# WOODBRIDGE SCHOOL DISTRICT New Woodbridge High School Bid Pac A

ADDENDUM NO.3 23 July 2012

Woodbridge School District New Woodbridge High School

ARCHITECT'S PROJECT NO: 11109

E-SK-01 Addendum No.3

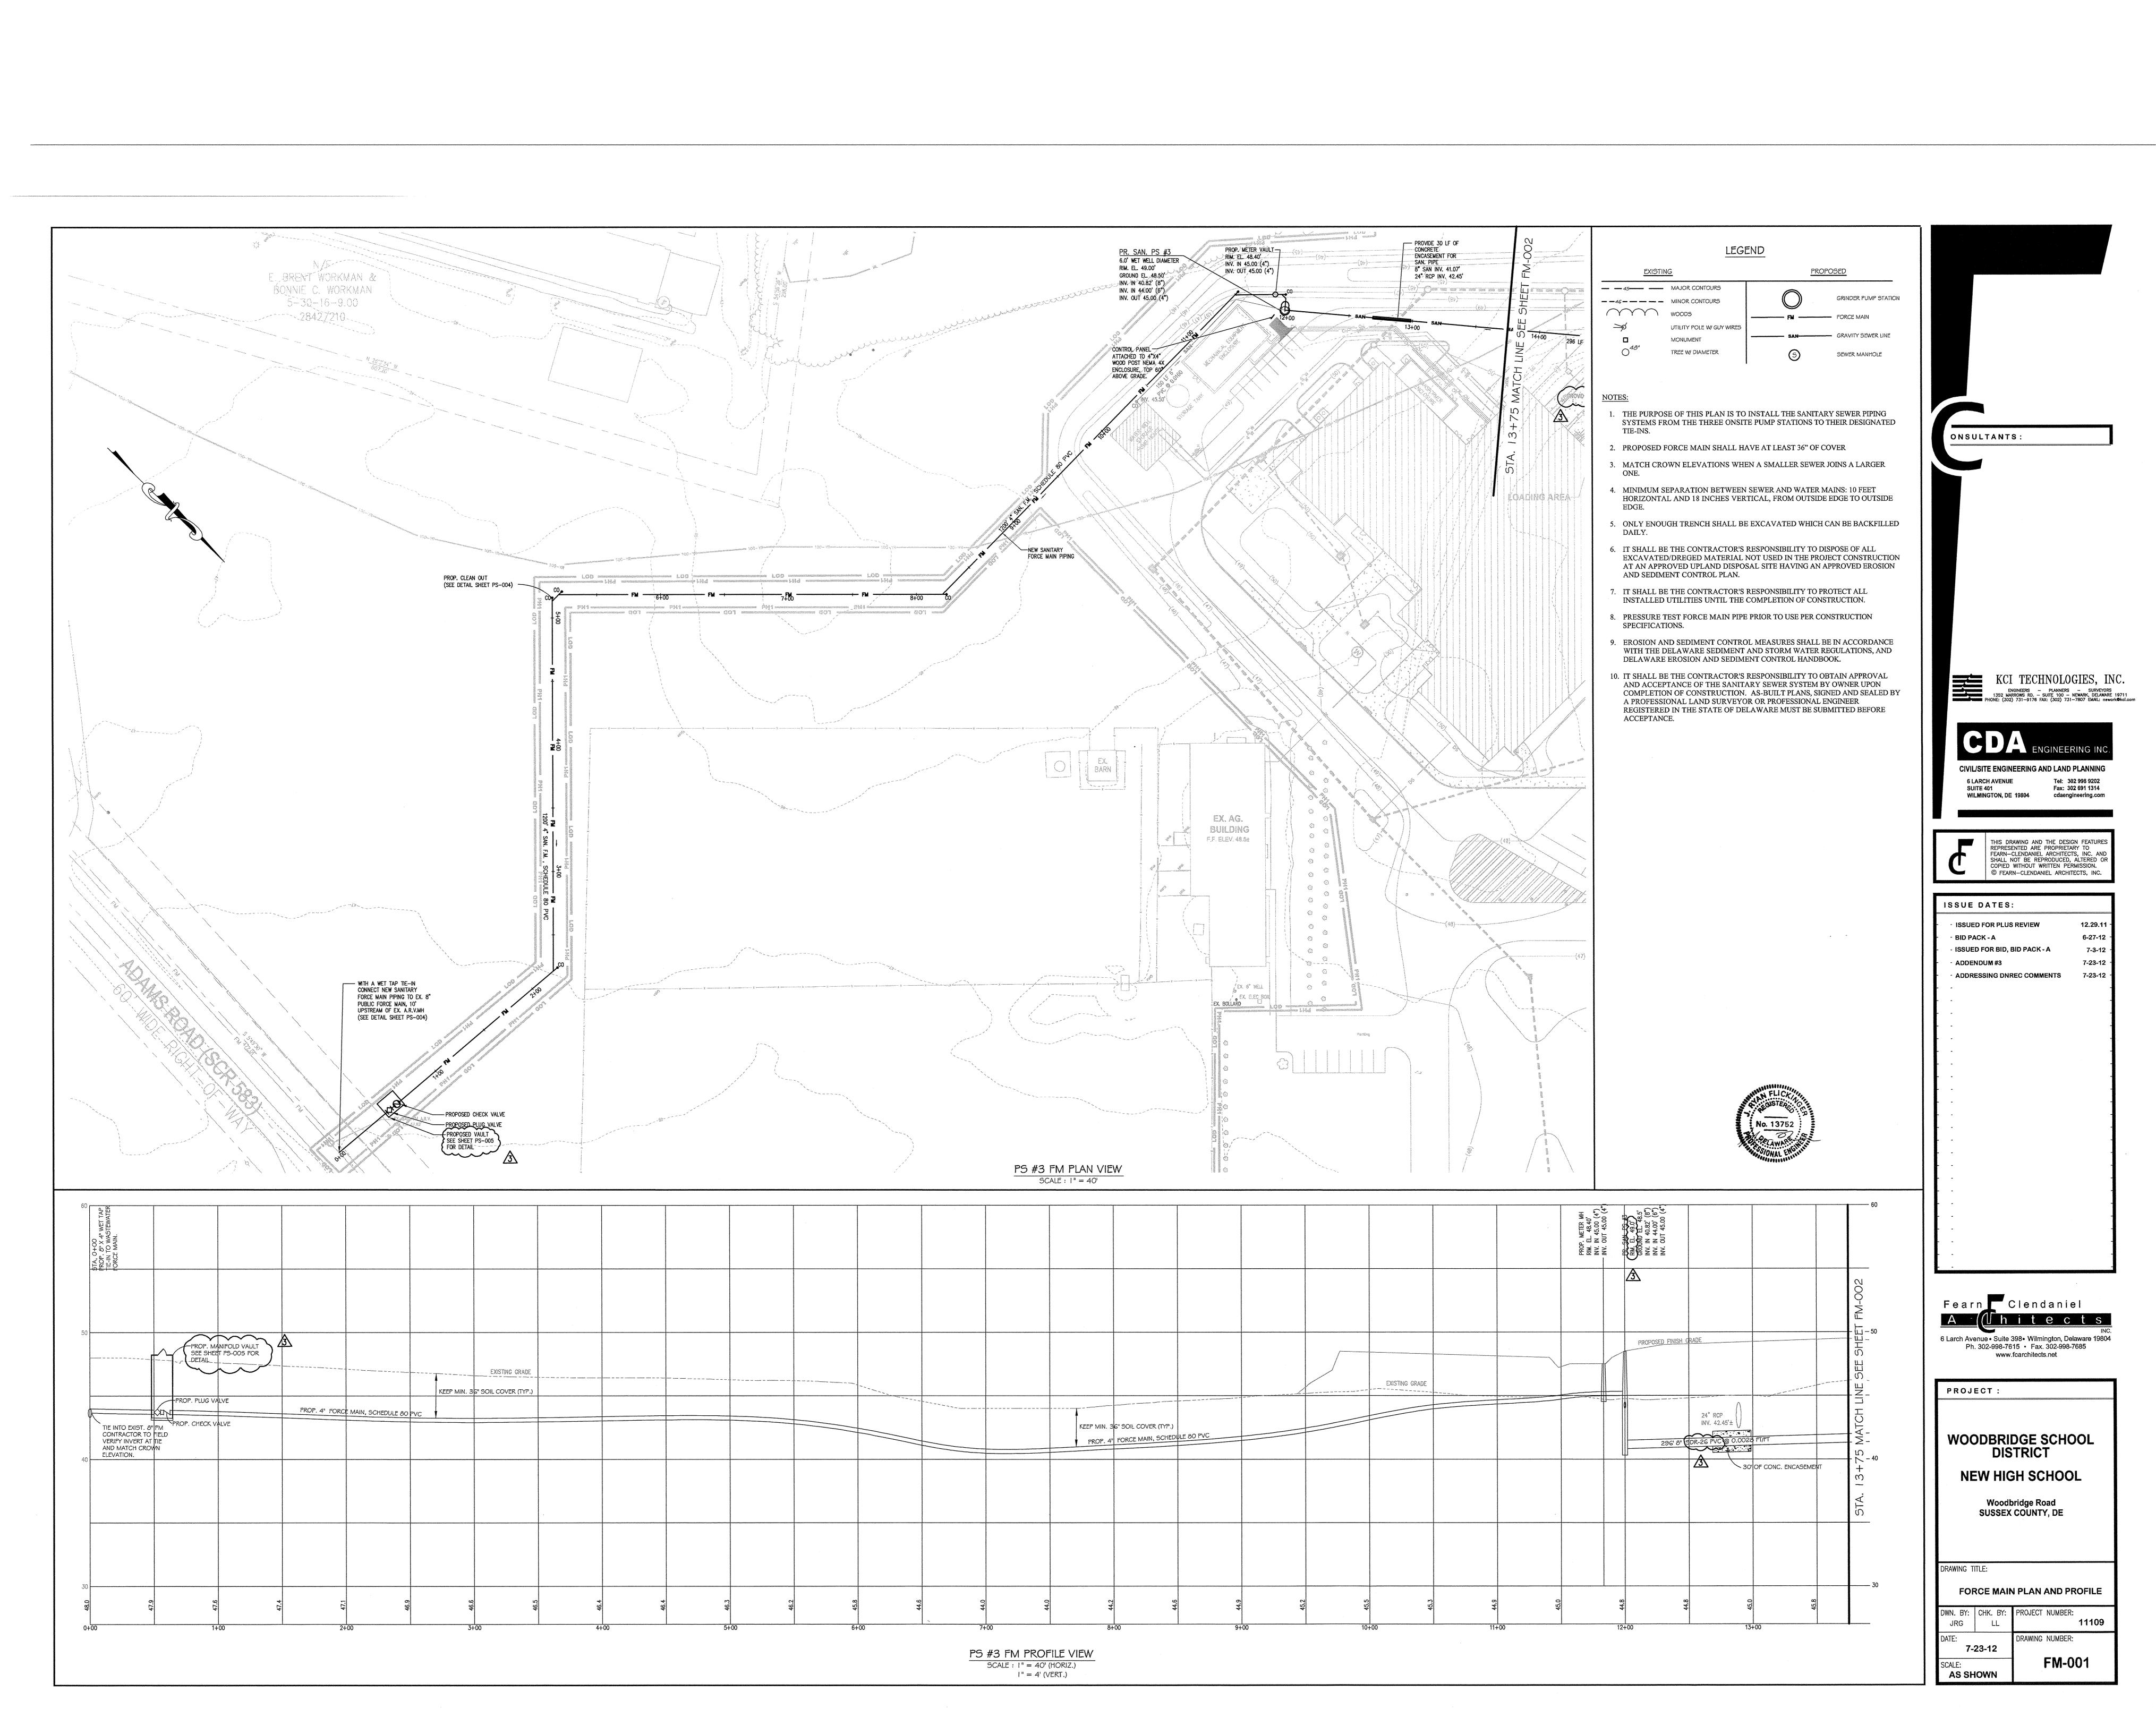
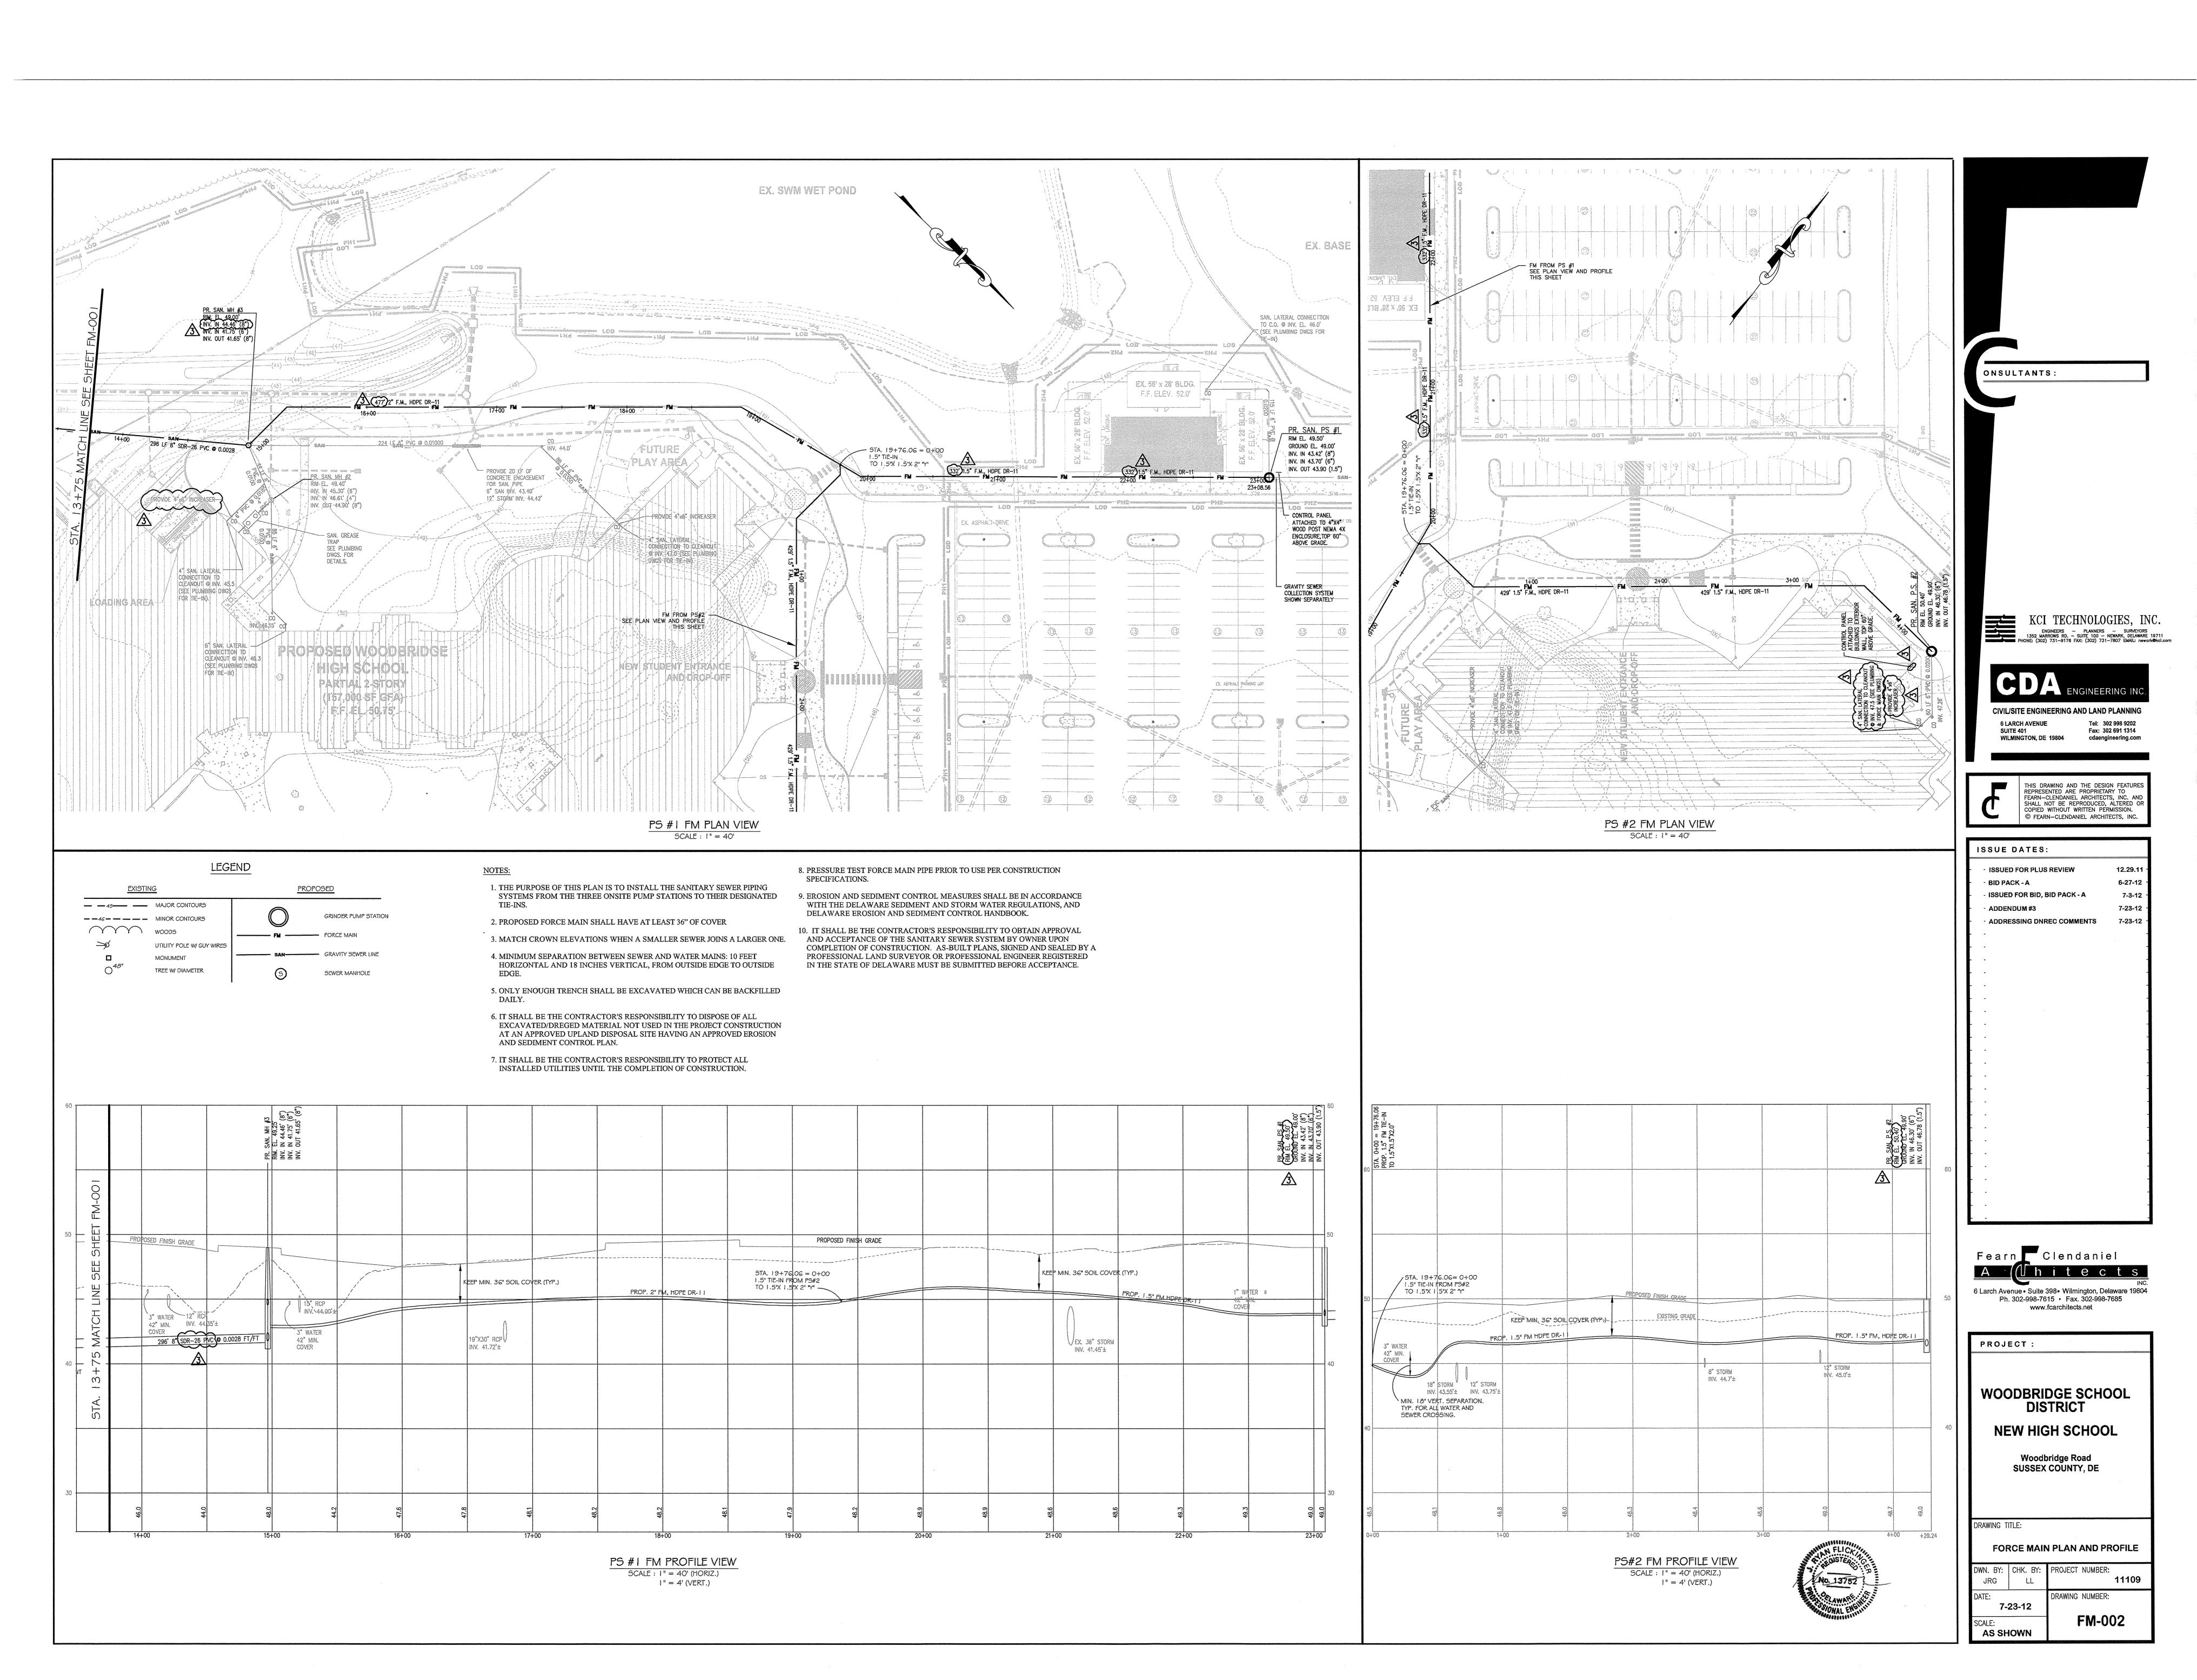
ADD SPARE CONDUITS FROM ELECTRICAL ROOM TO EXTERIOR OF BUILDING AS INDICATED. REFER TO DRAWING E50-OI FOR CONDUIT SIZES AND QUANTITIES.
